Gilgai and reactive soil geohazards in the City of Melton

Including the Planning Application for a
Place of Worship at 171-197 Harkness Rd,
Harkness

Prepared for: Melton City Council

Date: 31/08/2018

Figure 12. Proposed site classification for the Harkness area (1986).

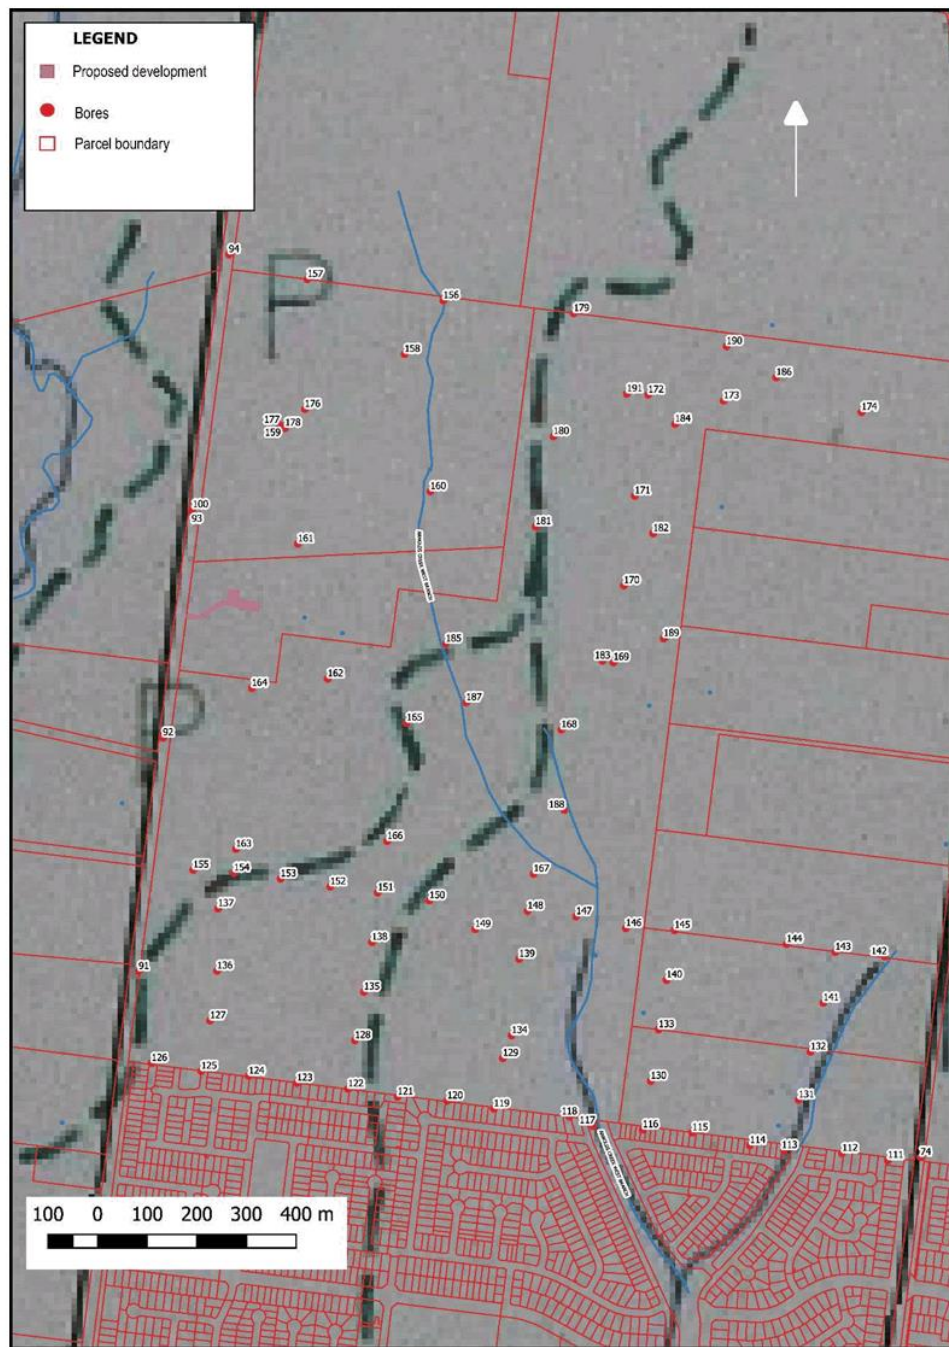
Unsurprisingly, given the limitations and constraints of the ground conditions, the area was classified a Class P (Problem) in AS2970-1986 (Figure 12). The original standard is now superseded by AS2870-2011, which defines:

The proposed development lies in the polygon designated as Class P (Problem soil).

Figure 13. Enlarged view of the modelled soil thickness map (1986), with the bore locations. The proposed development is underlain by soils modelled as around four metres thick.

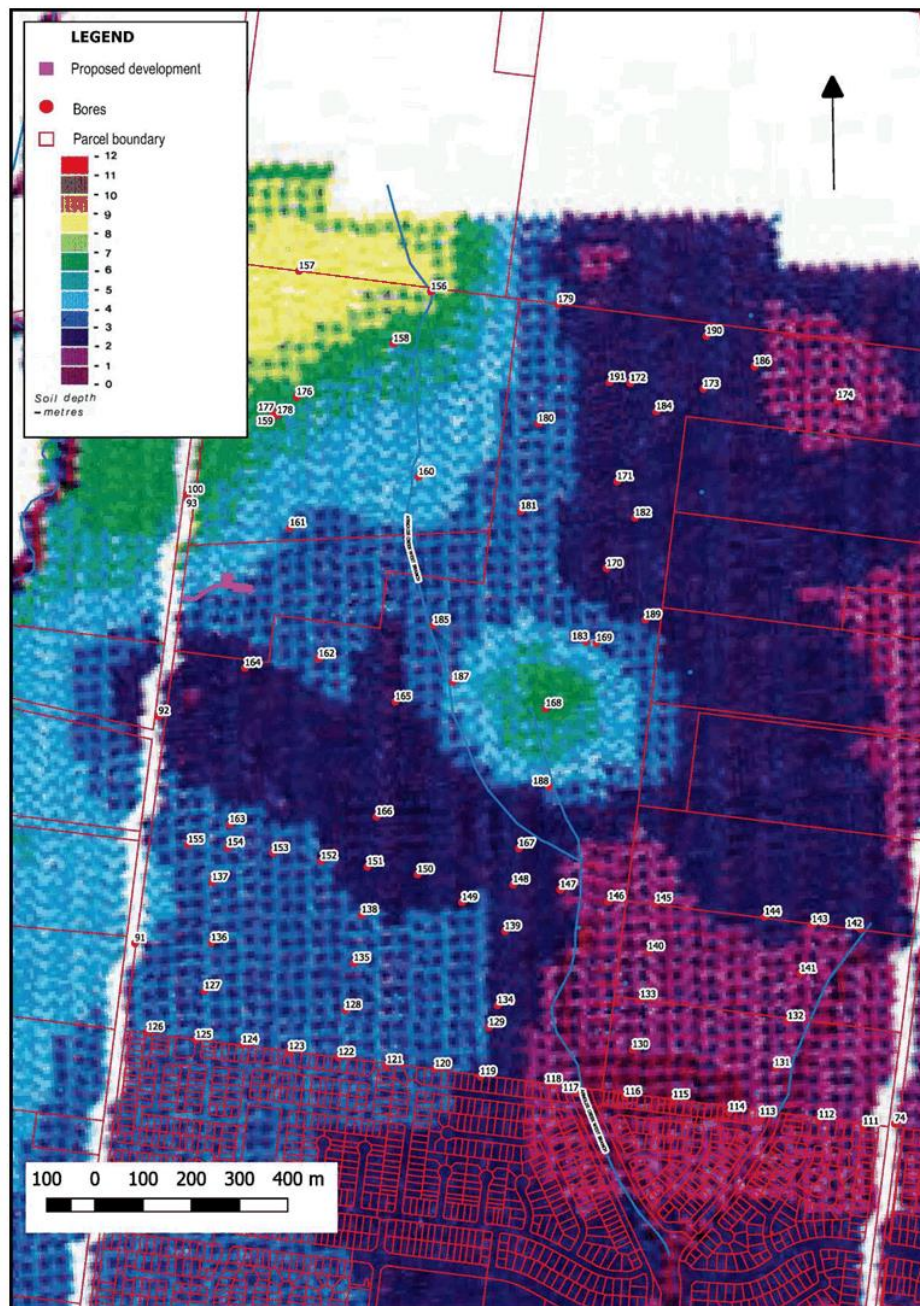
The closest bores to the site are designated as Djerriwarrh 93, 100, 161 and 164 (Figure 13). Bores 93 and 100, in the Harkness Road reserve north west of the site, show >4.2 metres and 7.5 metres of moist, very stiff, mottled yellow-brown and grey sandy silty clay. Bores 161 and 164, to the north east and south east respectively, show 3.2 metres of moist, stiff, fissured, mottled yellow brown and grey, silty clay overlying extremely weathered basalt. In both cases, the clay is fissured to the full depth of the bore, with soil shear (slickensides) evident. From these bores it is interpolated that the thickness of clay under the site would be around four metres (Figure 13). Four metres of highly to extremely reactive clay creates considerable seasonal movement (shrink-swell) and poses a challenge to the engineering and design of the development.

Figure 14. Some of the more obvious geohazards at the proposed development site as seen in aerial imagery. (source Melton City Council. Imagery captured January 16, 2018)

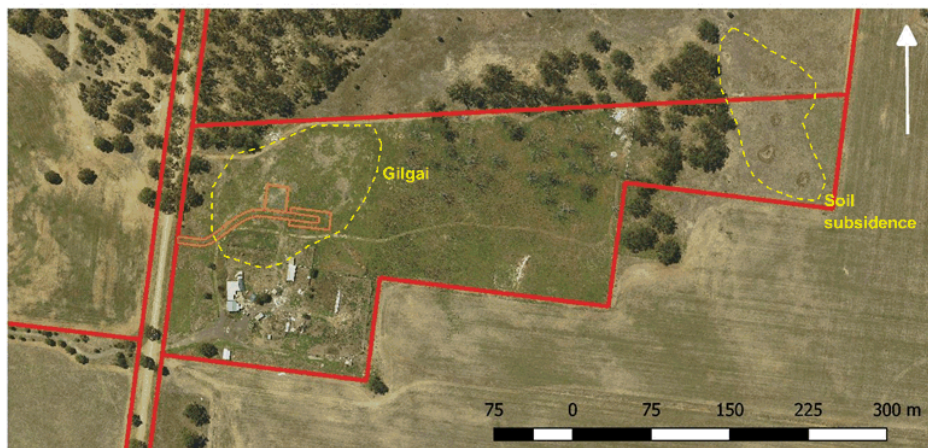
The soil collapse features are obvious on the east of the Applicant's site (Figure 14) and subtle gilgai depressions are noted on the western side, confirming² that the likelihood of geohazards at the site is Certain (Table 2). The consequence of the geohazards will depend entirely on the engineered solution. This would require a detailed geotechnical investigation to inform the potential engineered solutions and landscape design elements. The most challenging of these is the enduring management of soil moisture, which is the trigger for the geohazard processes. Hence, the wastewater disposal, runoff and storm water management, vegetation species selection and siting, garden irrigation, and the extents of the impervious surfaces are the most critical design considerations. However, even if the development could be engineered and designed to reduce the consequences of the geohazards to Moderate or Minor (Table 3), the risk remains High to Moderate (Table 4).

Figure 6: Approximate location of proposed mosque, view to east.

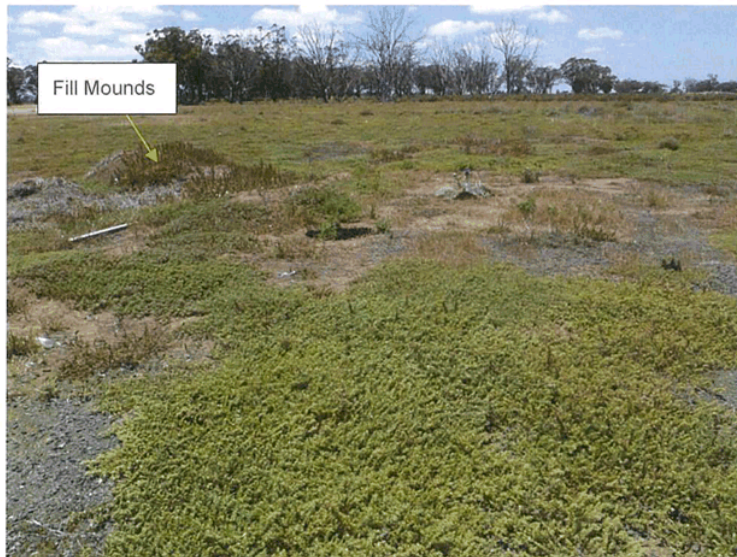
- 28) There are subtle gilgai features at the location of the proposed mosque (Figure 6). However, these features are not as pronounced as they are on other parts of the Site.

Figure 7: Example of a stiffened slab (Figure 3.1 from AS2870 (2011))¹¹

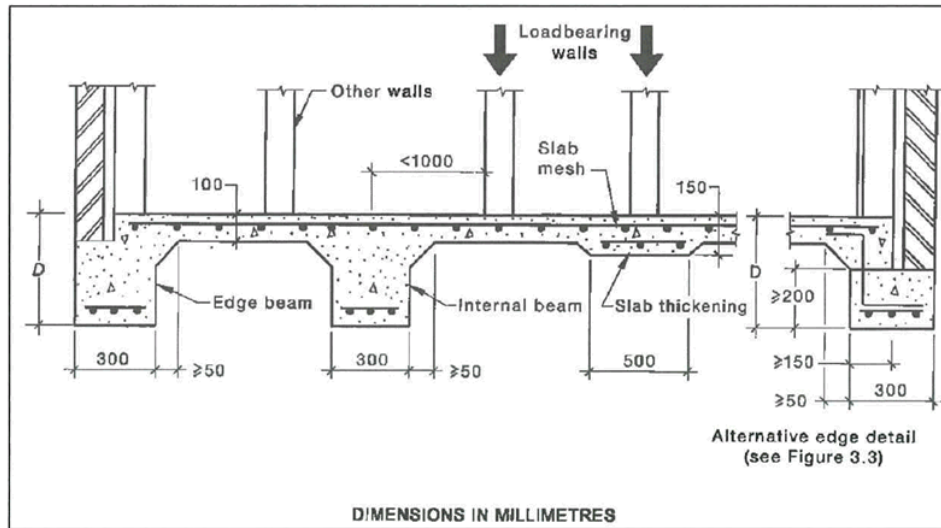
- 63) An example of a stiffened slab is presented in Figure 7.

- 64) If appropriately designed, I consider that a stiffened slab could:
- Reduce movement of the structure such that the risk of damage to the structure in ULS is acceptable.
